Agenda
Planning Commission
Council Chambers
Wednesday, August 20, 2014 - 7:00 P.M.

**Staff Review of Site Plan Application
Proposed Retail Plaza
1510 Washtenaw**

**Staff Review of Site Plan Application
Pat Walters & Sons - Expansion
636 S Mansfield**

**Staff Review of Site Plan Application
Complete Auto
311 S Grove**

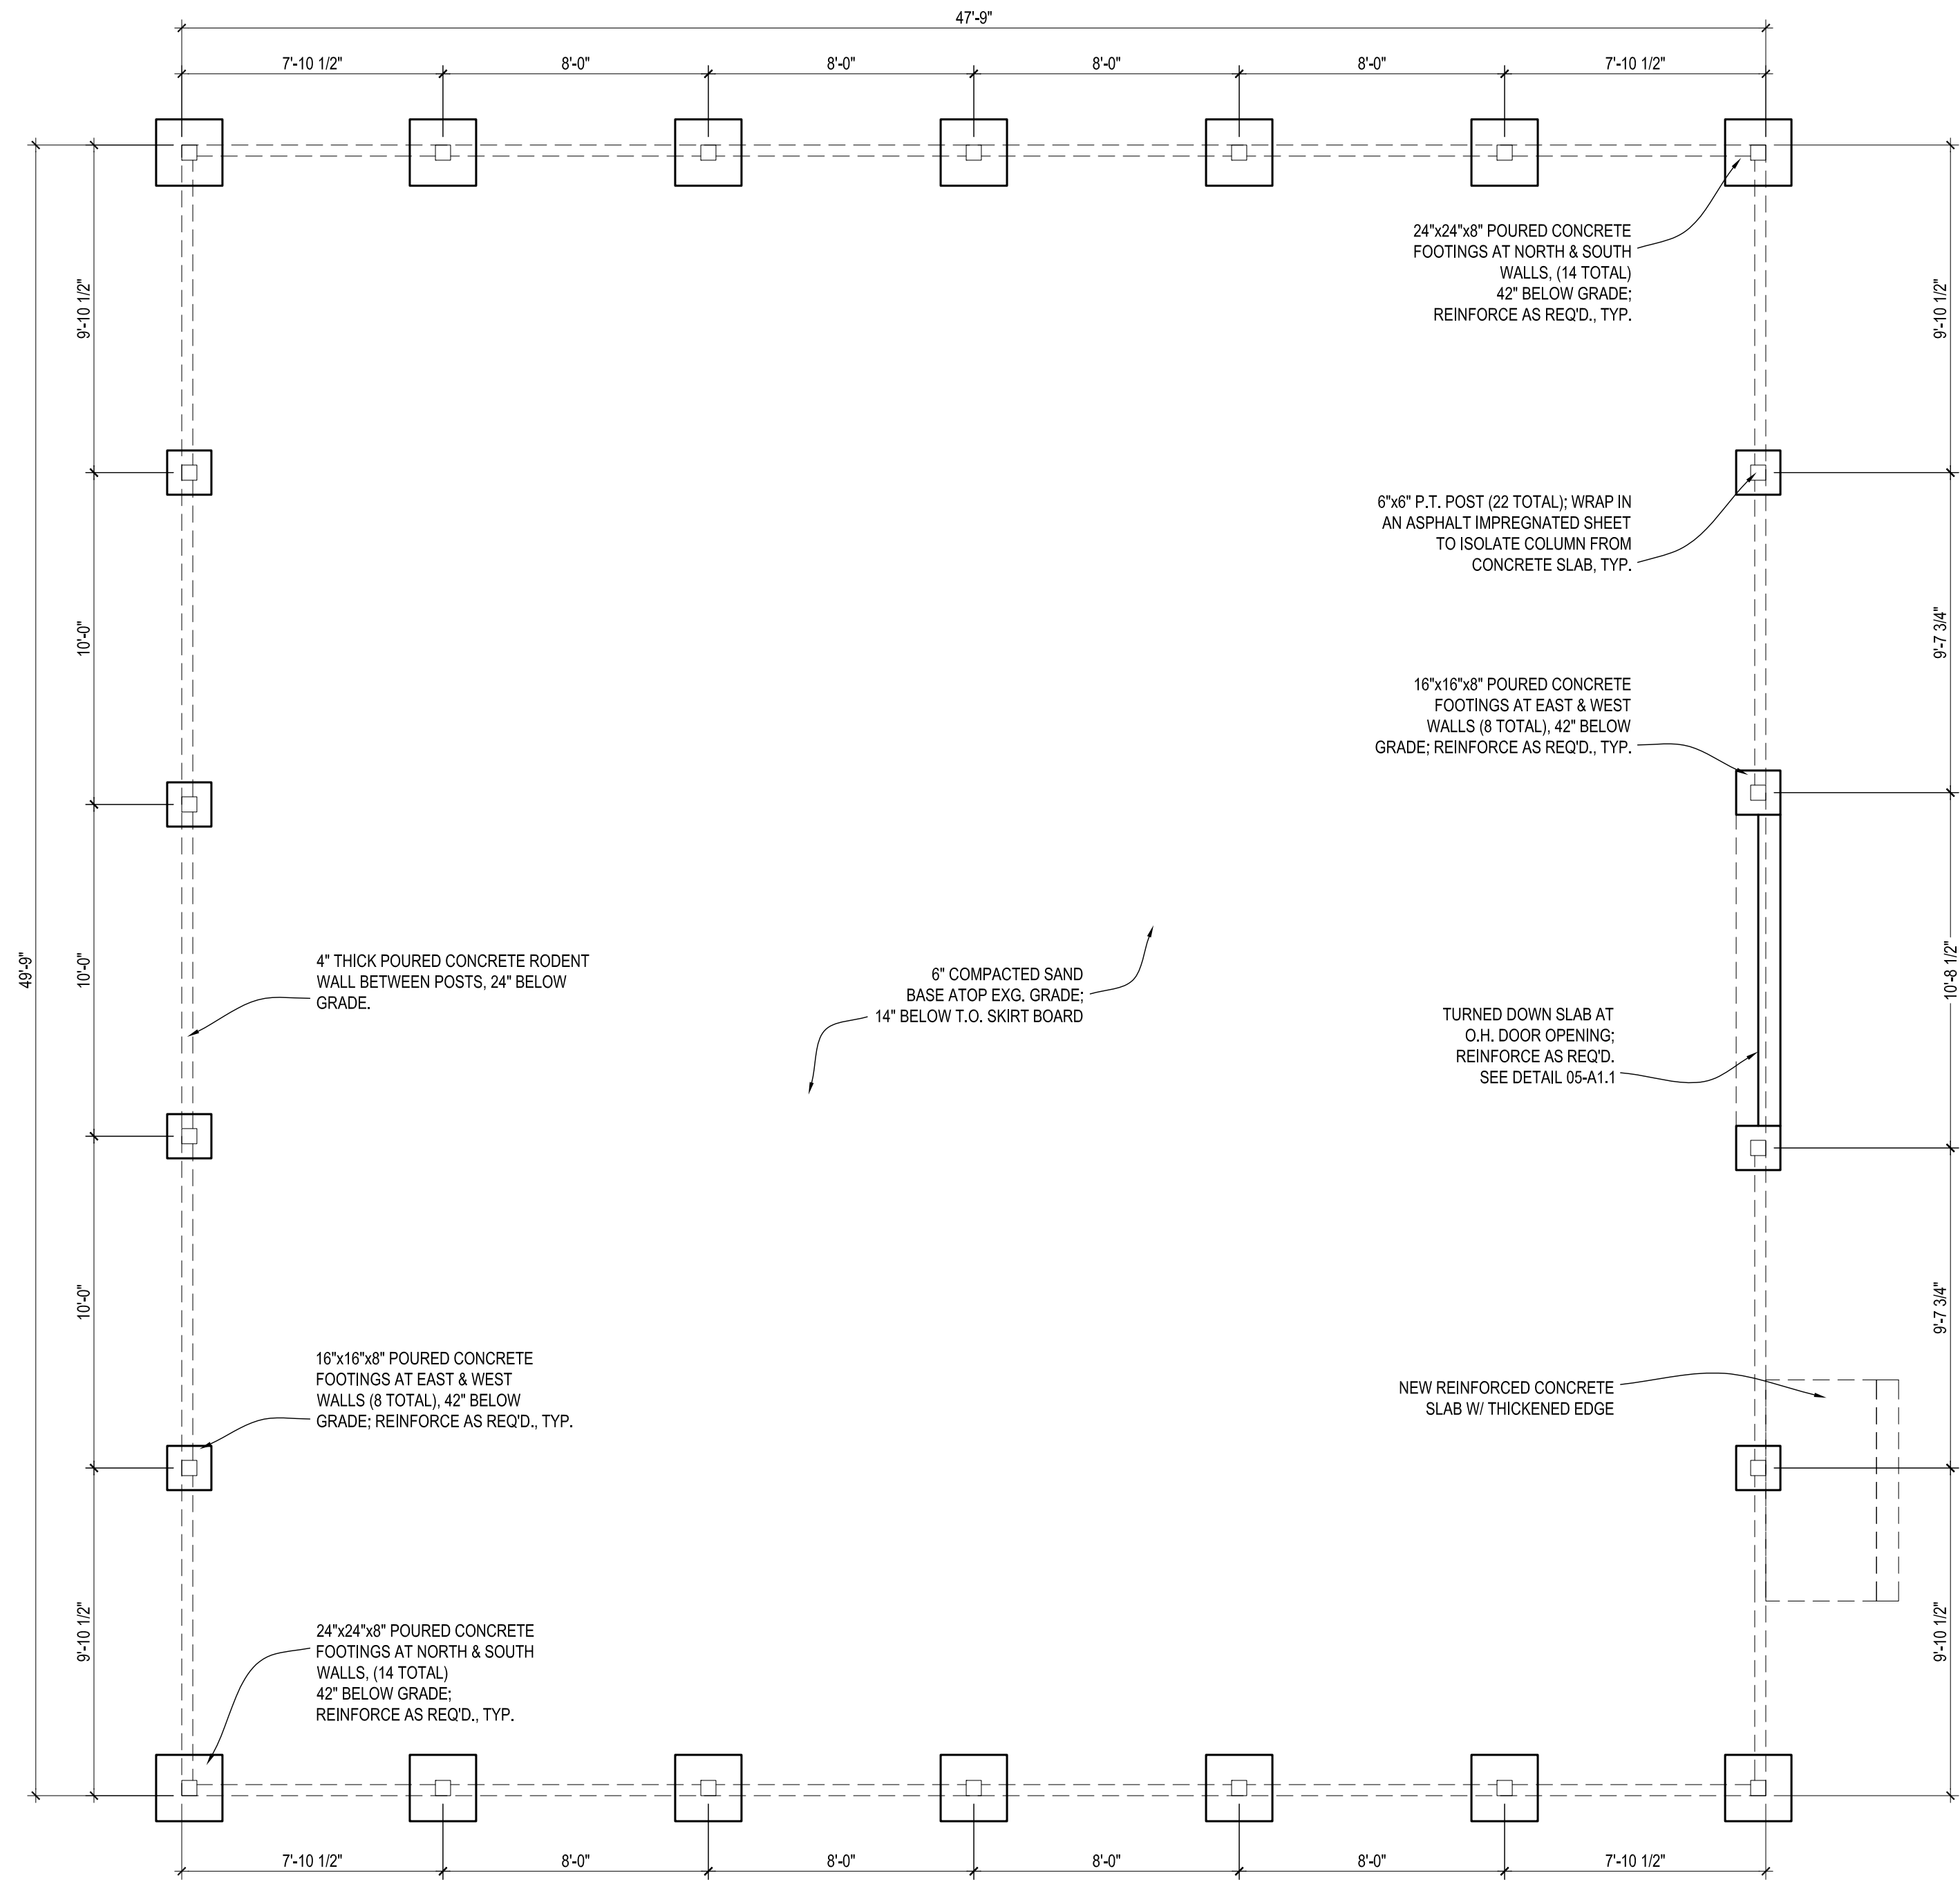
The applicant is requesting site plan approval for a new storage pole barn on S. Mansfield Street. The site plan is dated July 15, 2014. We have reviewed the plans and recommend site plan approval from an engineering standpoint. The applicant must address the following comments prior to submitting the plans for engineering review:

1. A separate drawing showing the proposed contours and site plan shall be provided, separate from the existing topography and site conditions.
2. Storm runoff from the proposed improvement shall be fully captured and handled onsite by the existing storm system. An easement will be required from the adjoining property (Lot 7) if the existing drainage swale is to be used to channel new runoff from the improved area.

4. The type and location of all existing structures will need to be field-verified.
5. It appears that neither new water main nor sanitary sewer is proposed. If proposed, water main and sanitary sewer shall be shown on plans. Review and approval from YCUA will be required.

6. We understand that payment in lieu of construction is being recommended for the proposed sidewalk. The proposed sidewalk shall be removed from the plan and replaced with a note stating so.

7. A truck circulation plan with turning movements for the largest anticipated vehicle shall be provided.
8. Cross sections are required for all paved areas, including HMA, concrete, and sidewalks.

9. Slopes shall be shown for all paved drive areas.
10. The owner's telephone number shall be provided on the site plan.
11. Review and approval will be required from the Fire Department.

12. A note shall be added to the plans indicating "distressed or damaged areas of the existing parking lot will be repaired as part of the project".
